Re: Patent Application of Brad A. Armstrong

Serial No.: 08/677,378 Filed: 07/05/96

Title: IMAGE CONTROLLERS WITH SHEET CONNECTED SENSORS
(as amended)

IN RESPONSE TO THE OUTSTANDING OFFICE ACTION OF 08/31/00

PRIOR ART
FIG. 37

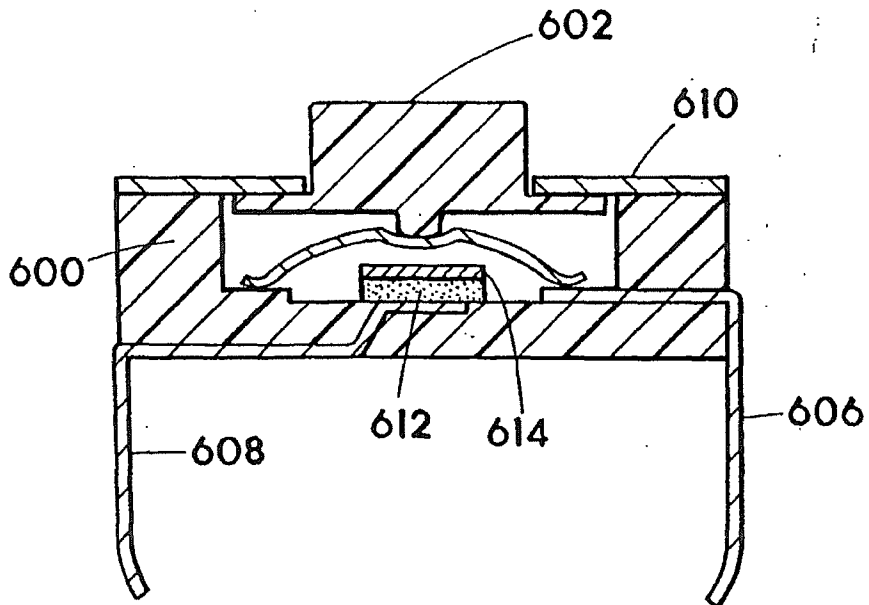
Point 4 has been read. Drawing Figure 37 is prior art and is labeled as such in the new substitute formal drawing included herewith. A Letter to the Official Draftsperson is also herewith included. Would the Examiner please be so kind as to properly route the substitute drawing so that it is the drawing used for the Patent publication. Thank you.

Regarding the issue of Fig. 38. Applicant understands that the Examiner may have perceived Fig. 38 as prior art from reading the first sentence starting on line 16 on page 39, but therein Applicant is only describing a "typical package body 600" meaning that the body of the Fig. 38 sensor may use a prior art style body, not meaning that the sensor of Fig. 38 is prior art, rather lines 17-29 assert that Fig. 38 is a novel sensor.

Figure 38 is NOT a prior art figure or device. In the specification, on page 39 lines 17-29, describes the sensor of Fig. 38 as being novel at least due to the inclusion of "an additional very important element" (line 17), being a "pressure sensitive electrical element 612" (line 20). Applicant does not admit Fig. 38 is prior art and in fact states on lines 27-29 "I believe that integration of pressure sensitive technology into a tactile-snap through sensor package is novel...".

Sir:
New formal drawing sheet 32 of 50 originally submitted for the above application is enclosed, corrected as required by the Patent Examiner to include the words "PRIOR ART" associated with Fig. 37. The sheet includes only drawing Figs. 37 and 38 Please substitute this sheet for the corresponding sheet on file.
Thank you.

IMAGE CONTROLLERS WITH SHEET
CONNECTED SENSORS (as amended)
Brad A. Armstrong, Inventor
Corrected drawing sheet 32 of 50
(substitute for original)
